Errata Sheet

Product Family:	DL205	Date:	October 2018
Manual Number	D2-HP-M		
Revision and Date	1st Edition, Rev. A; May, 1998

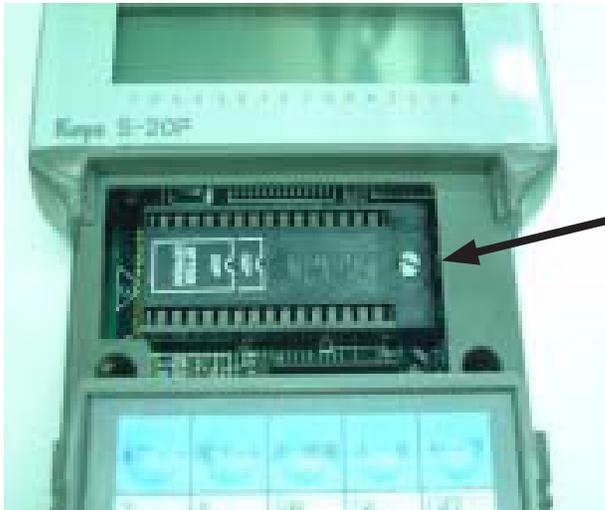
In late 2004, a design change occurred that changed how the EEPROM locks into place. The drawings and text on pages 1-6, 5-4 and 5-5 show the old design, whereby the EEPROM was held into place by a small lever. To replace the EEPROM, raise the lever to loosen the EEPROM. Once the replacement EEPROM is inserted in place, press the lever down to secure it.

On re-designed models, the lever arrangement was replaced by a locking screw, as shown in the photo below. Turn the screw clockwise to loosen and counterclockwise to tighten the EEPROM.

Locking screw secures EEPROM in place. Locking screw replaces lever on models manufactured after October 2004.

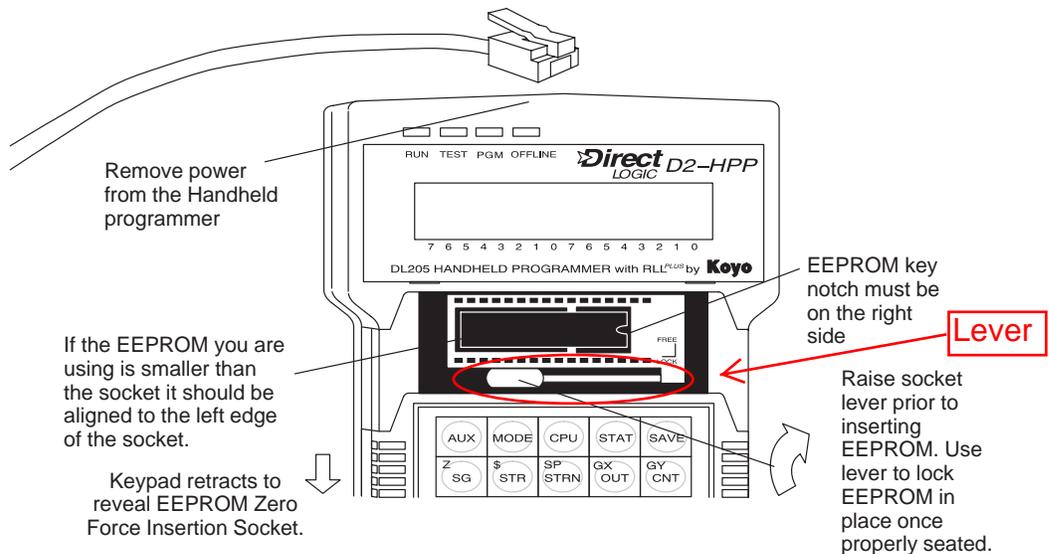
See Errata Sheet at the beginning of this file. In late 2004 this lever that secures the EEPROM was replaced by a securing screw.

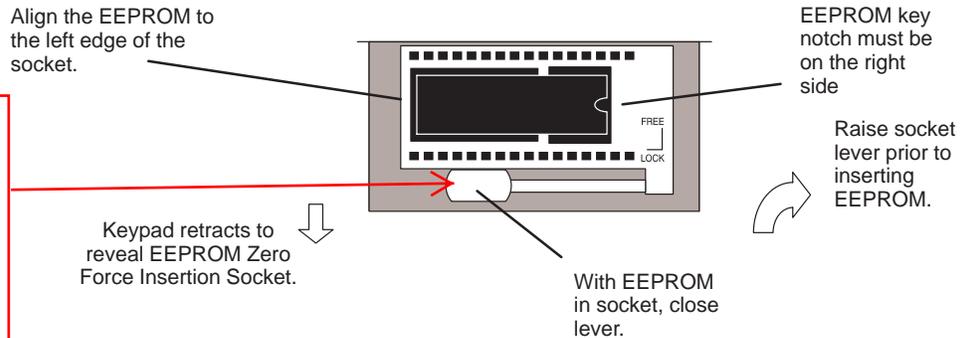
See Errata Sheet at the beginning of this file. In late 2004 this lever that secures the EEPROM was replaced by a securing screw.
